Town of Hilton Head Island
Design Review Board Meeting
Tuesday, November 10, 2020 – 1:15 p.m.
AGENDA

DESIGN TEAM/DRB COMMENT SHEET

PROJECT NAME: 28 Shelter Cove Lane

DESIGN TEAM/DRB COMMENT SHEET

DRB SUBMITTAL
A-002
 OUTDOOR BAR

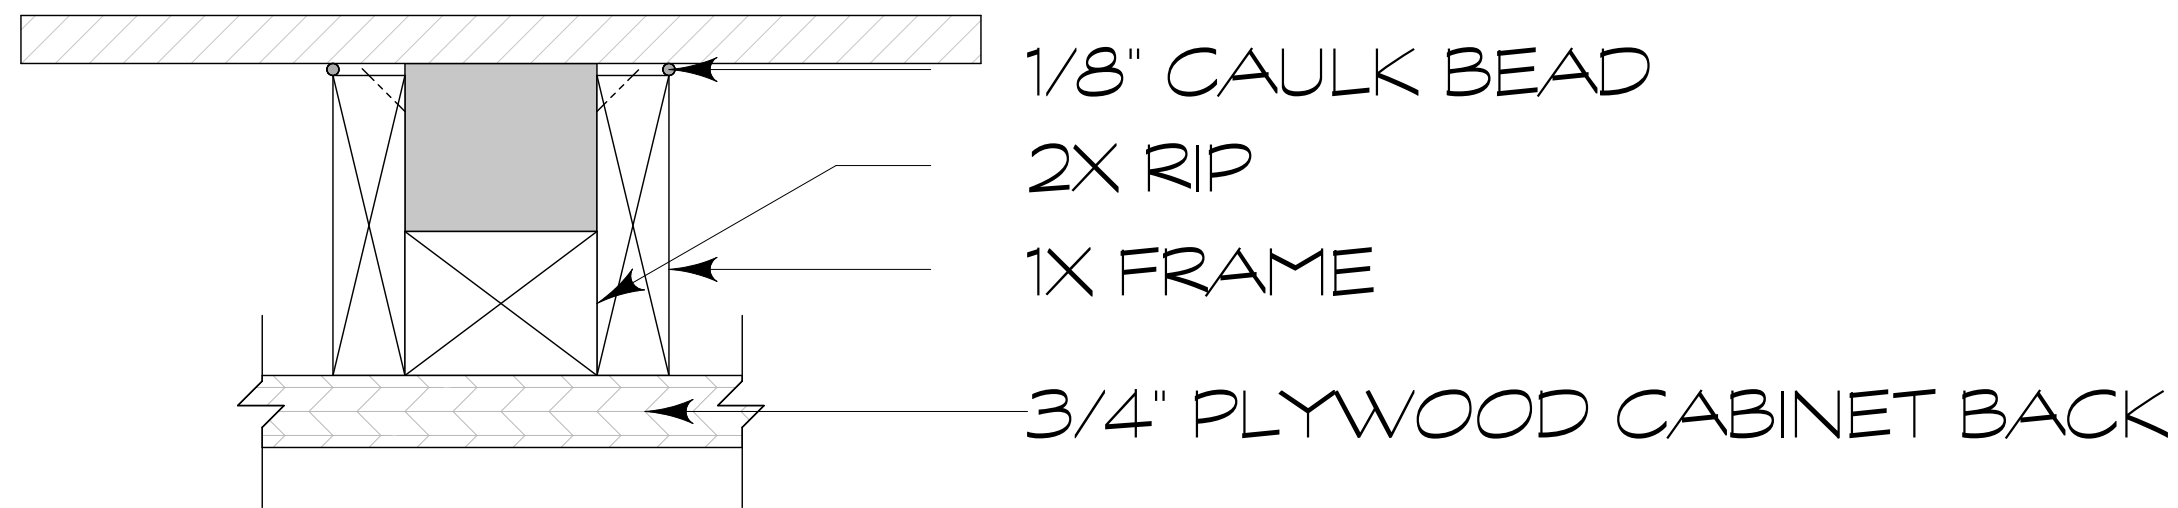
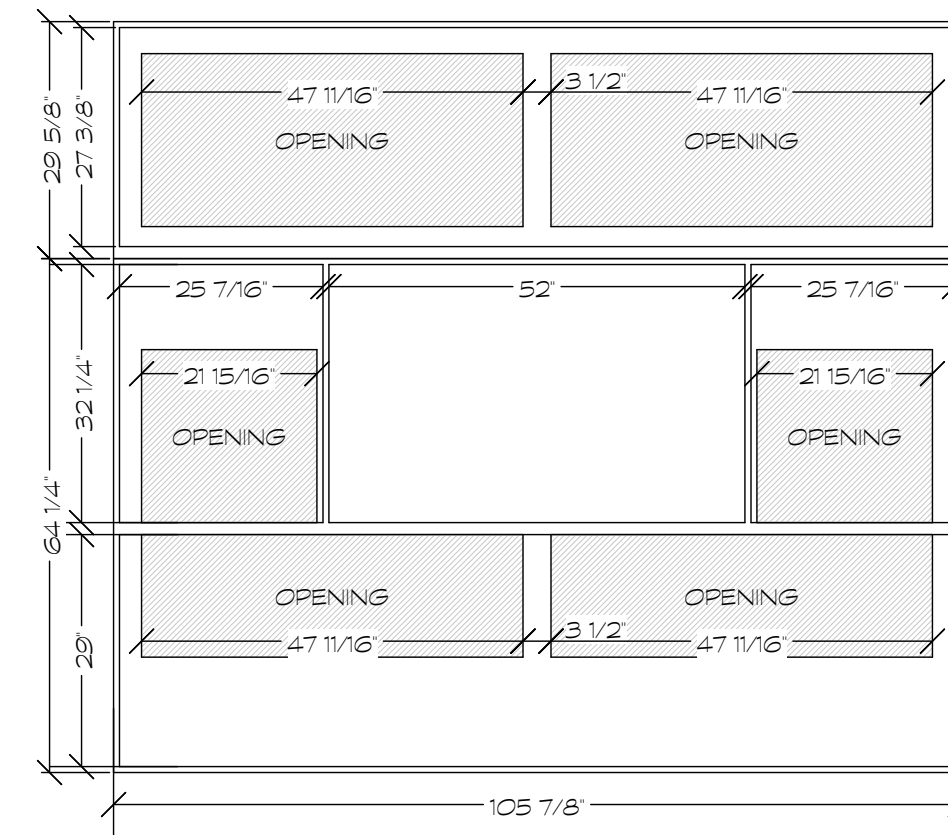
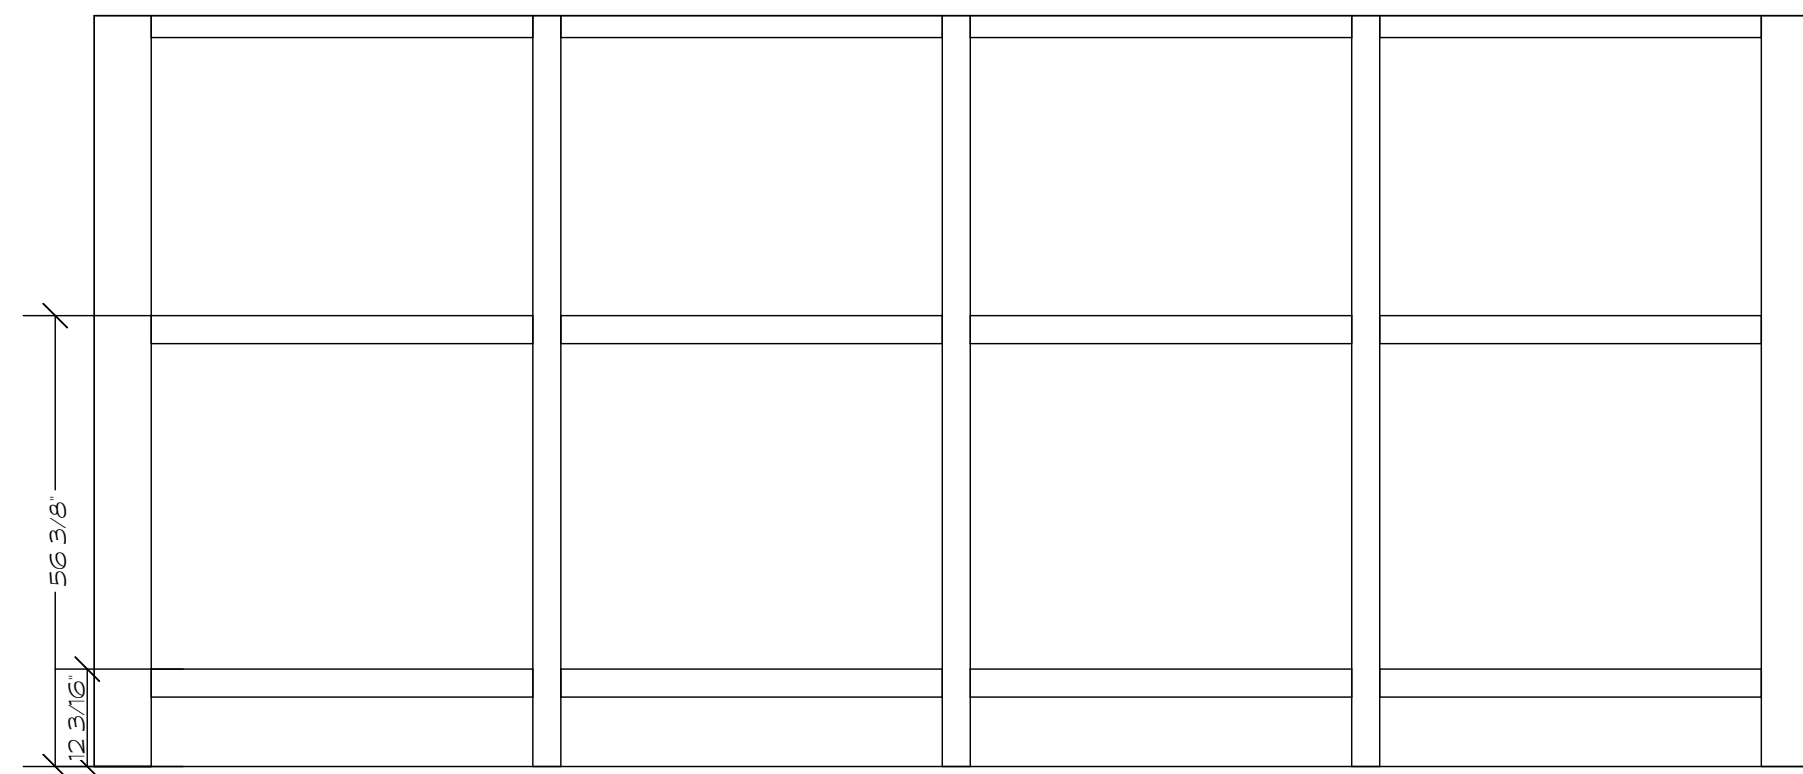
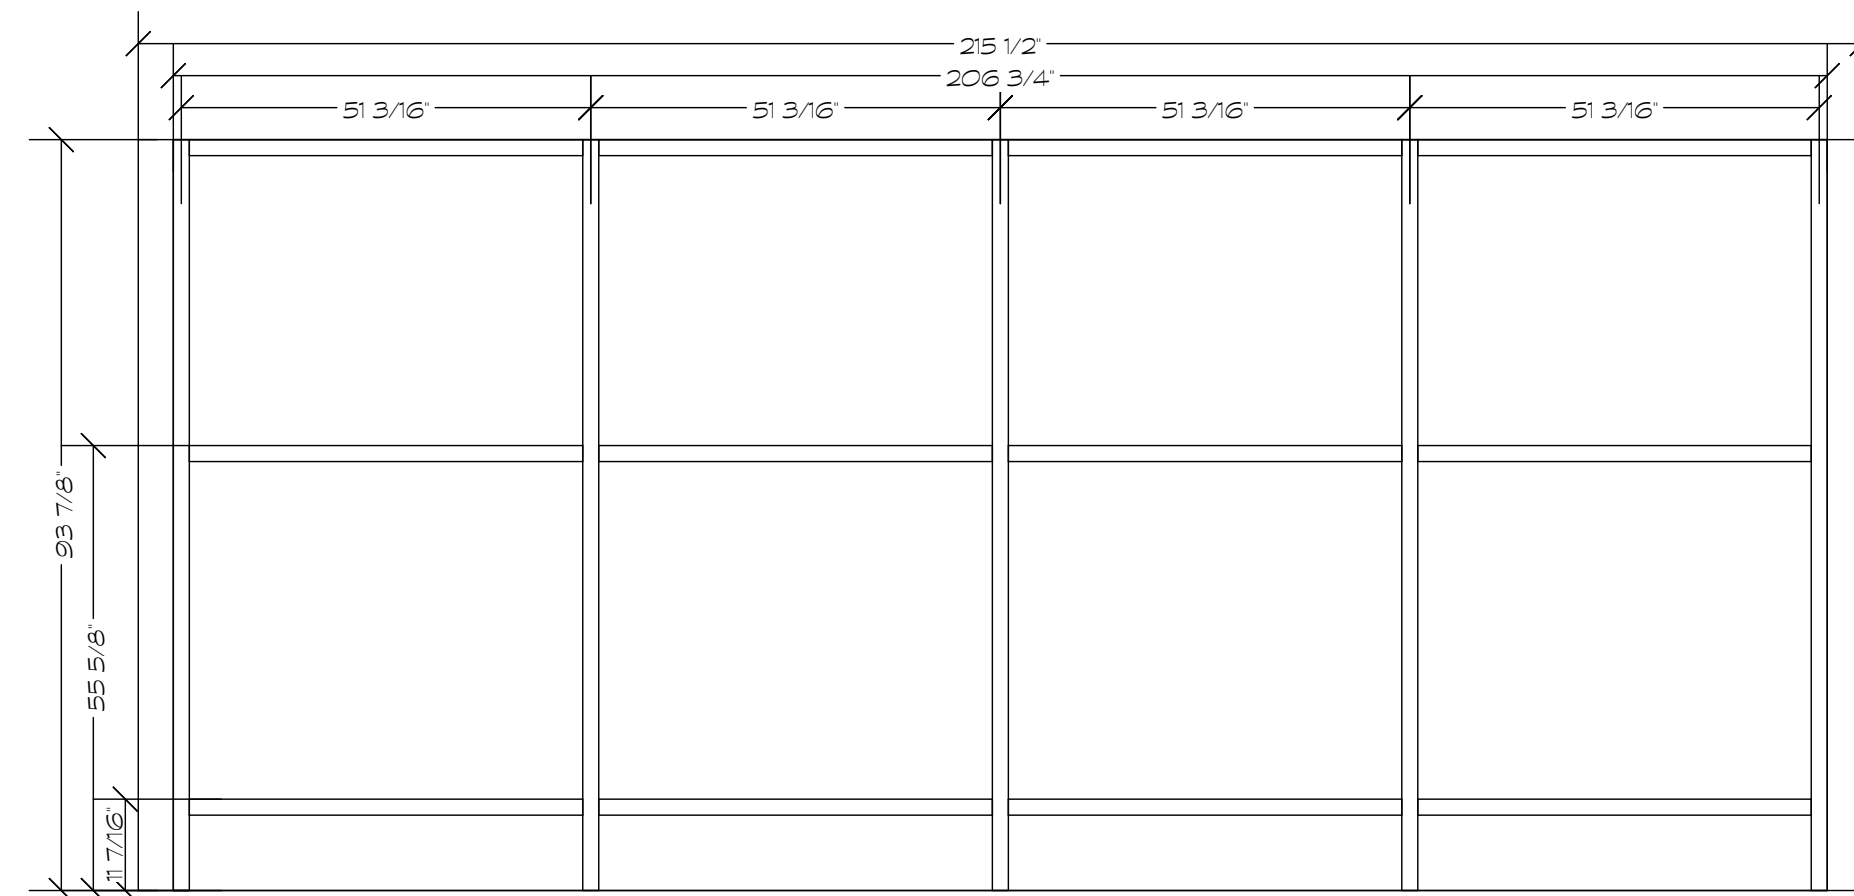
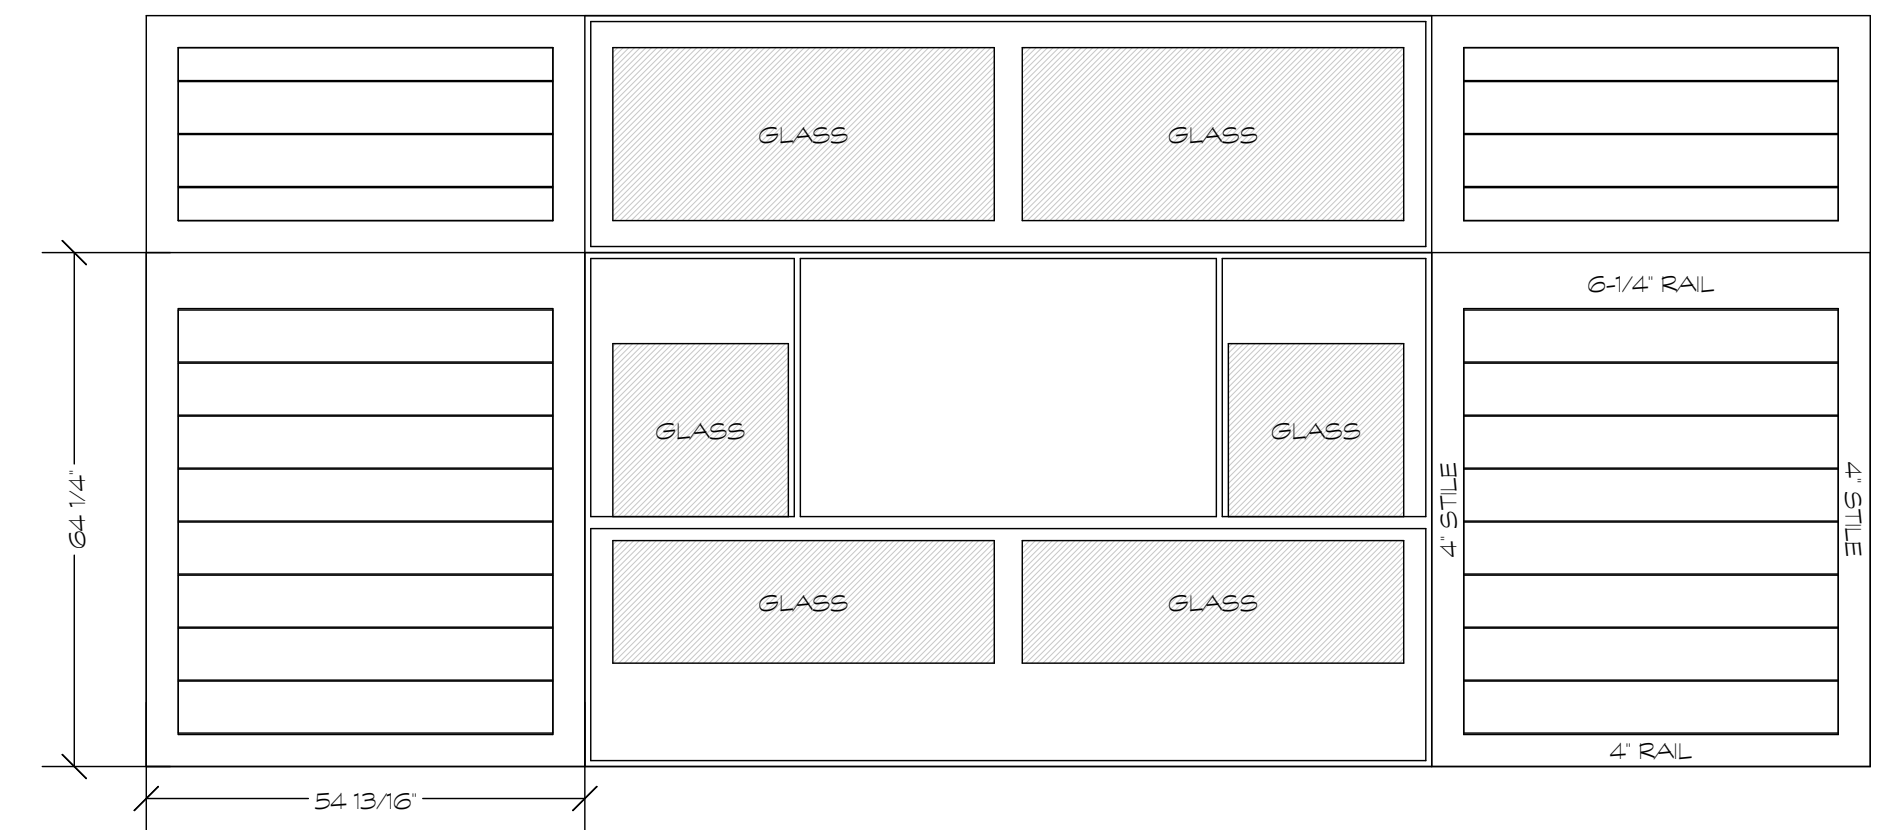
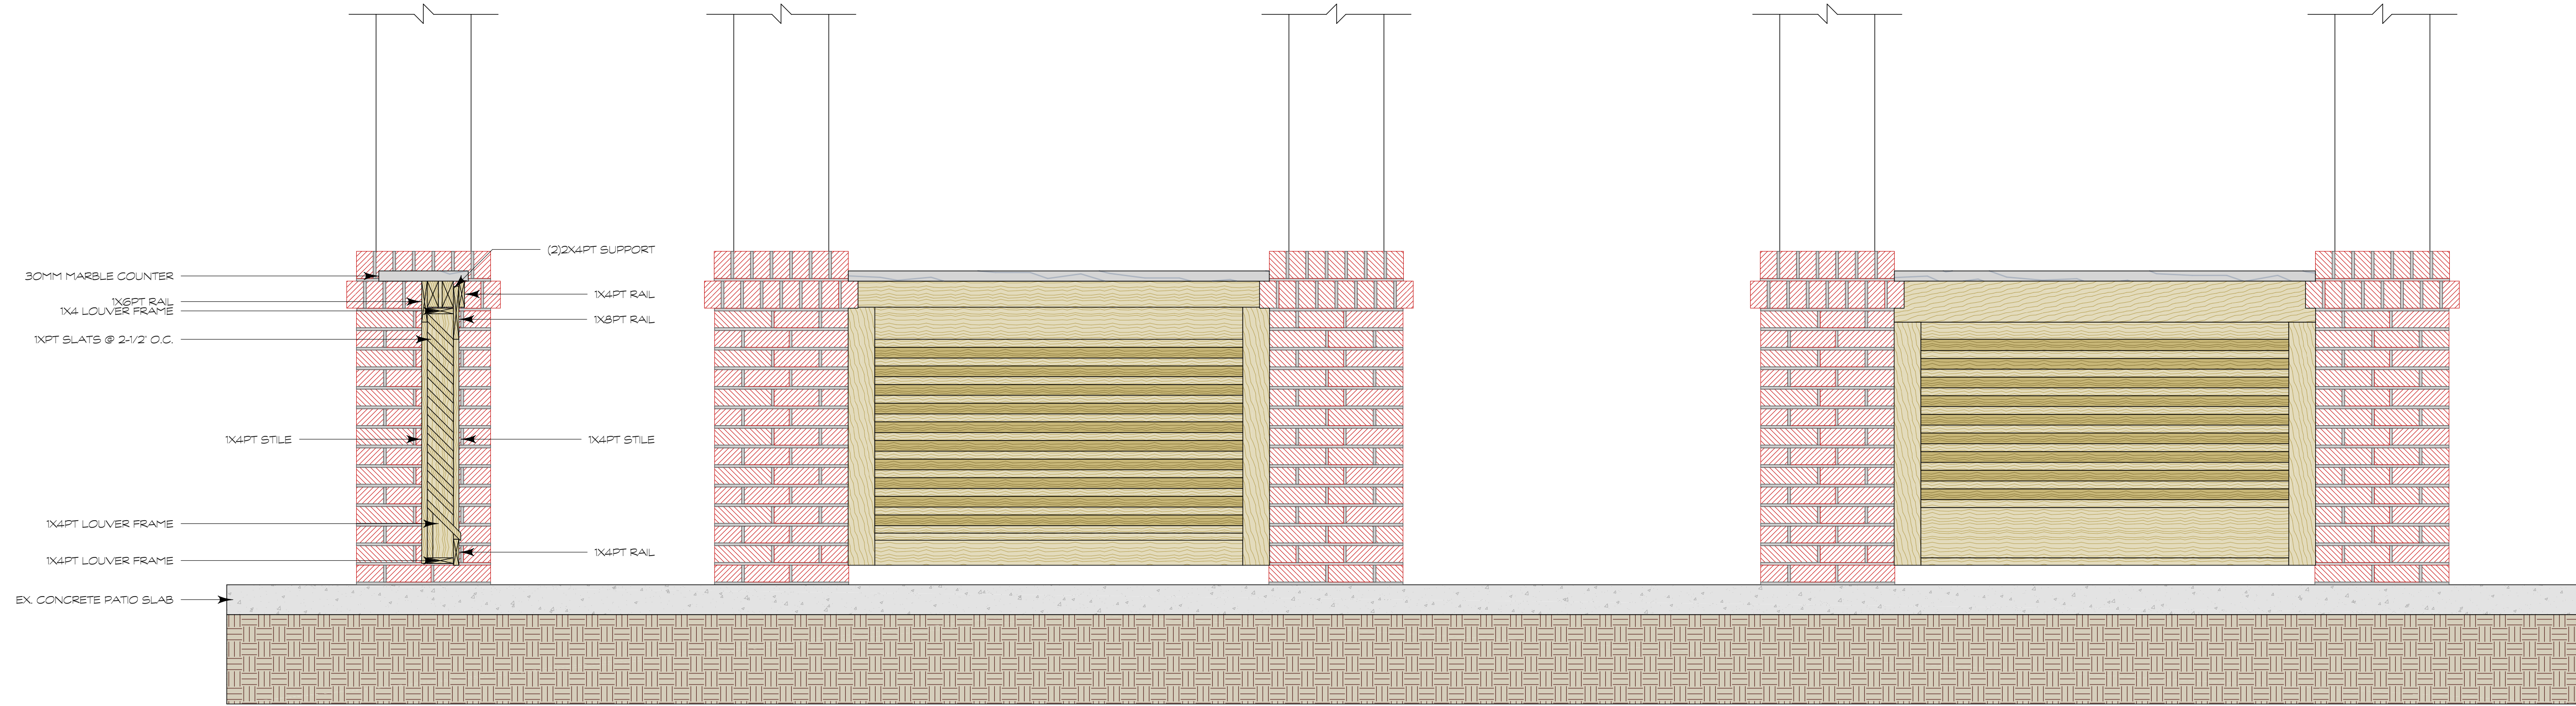
4. (narrative item 3) The proposed bar covers the window that balances the building exterior. Staff suggest the bar be detailed to look more like shutters when closed eliminating any glass.

DRB SUBMITTAL
A-003
DETAILS

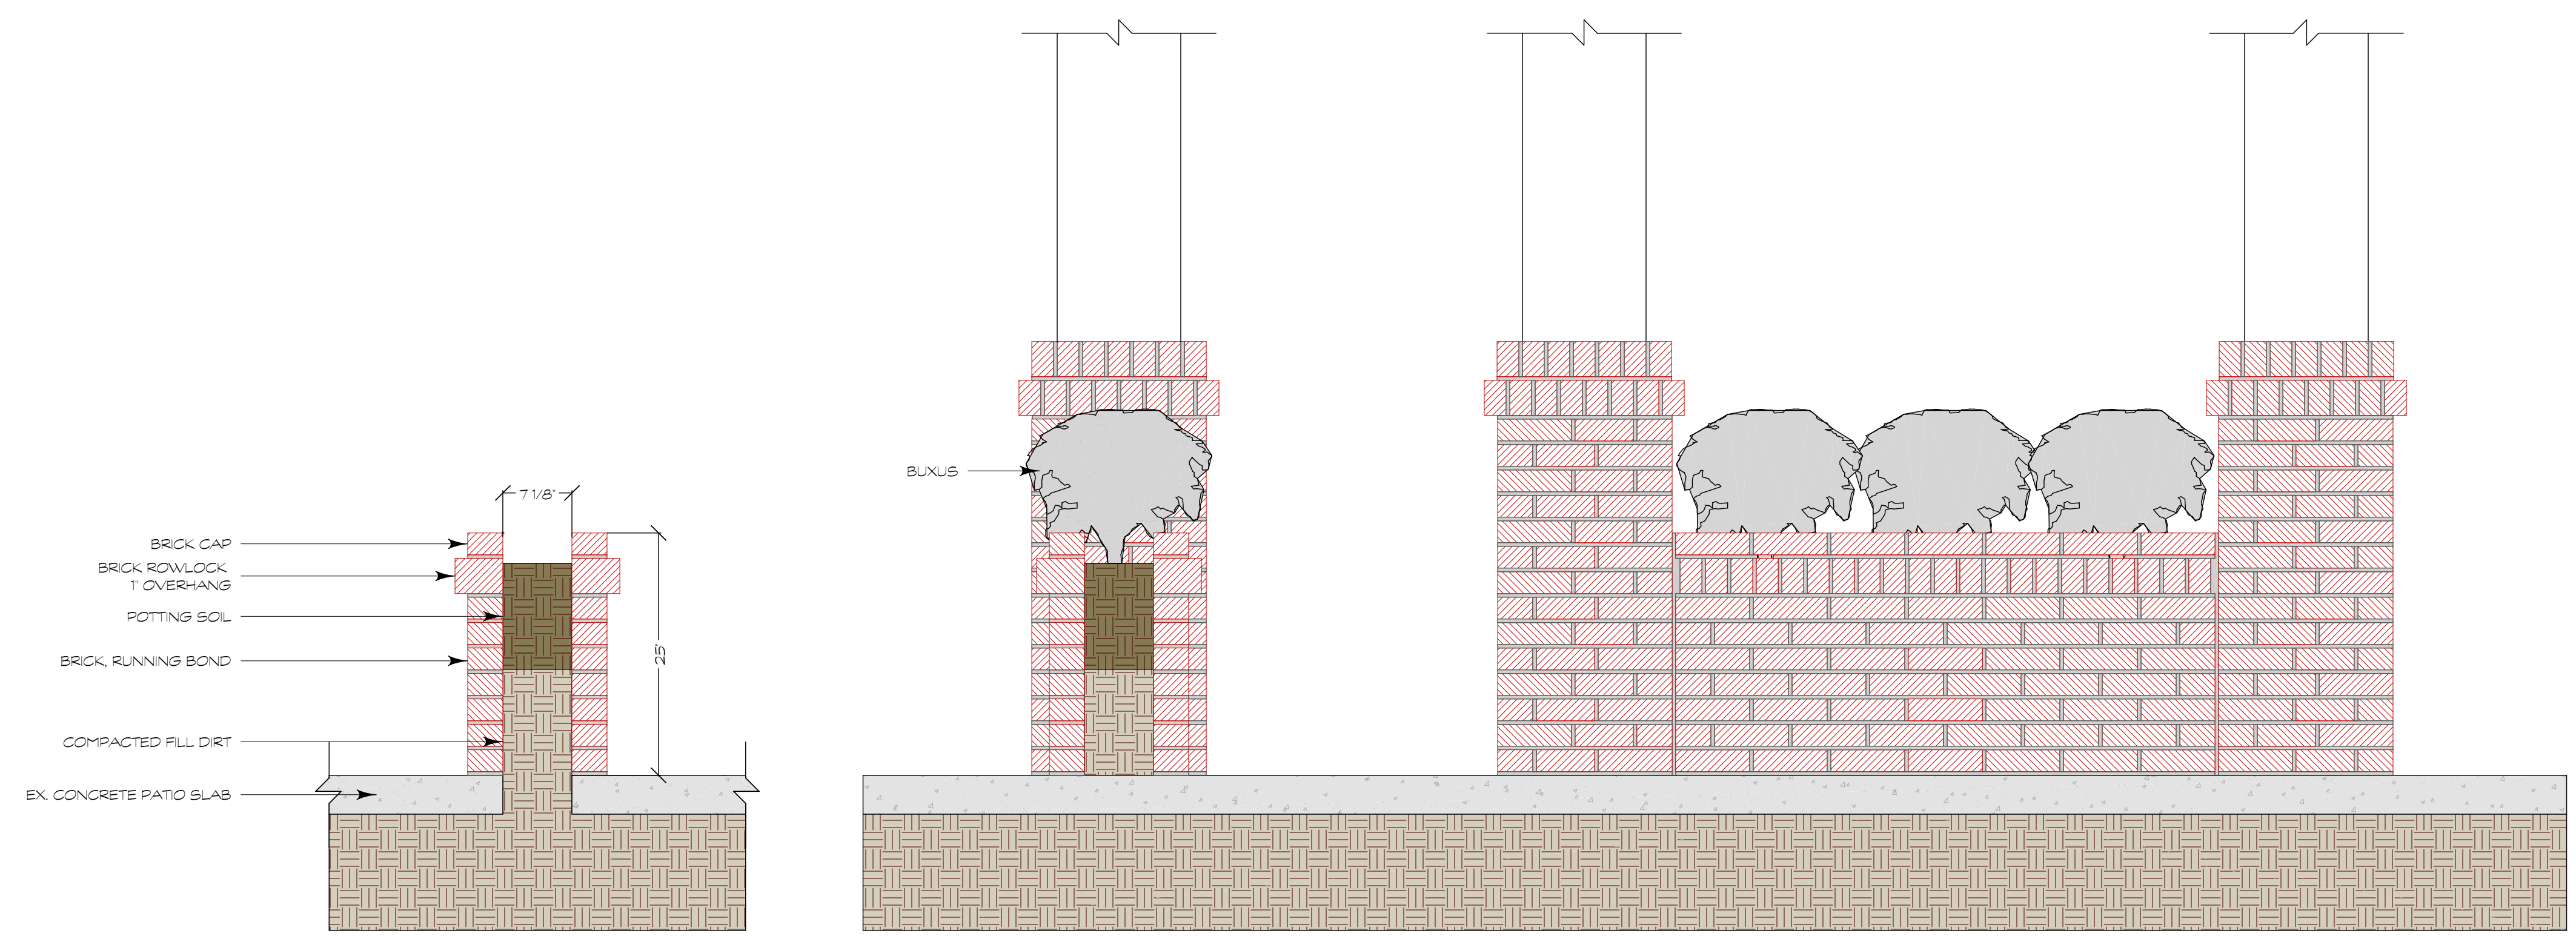
<i>MISC COMMENTS/QUESTIONS</i>
1. This project was withdrawn prior to a vote at the Oct. 27 th meeting.
2. (narrative item 1) The bar louvers screens are proposed to be moved so brick pier is proud of louvers to comply with DRB comments.

3. (narrative item 2) Given the narrow width of the proposed brick planter, Staff suggest the box planters, from the Oct. 27 th application be reconsidered.
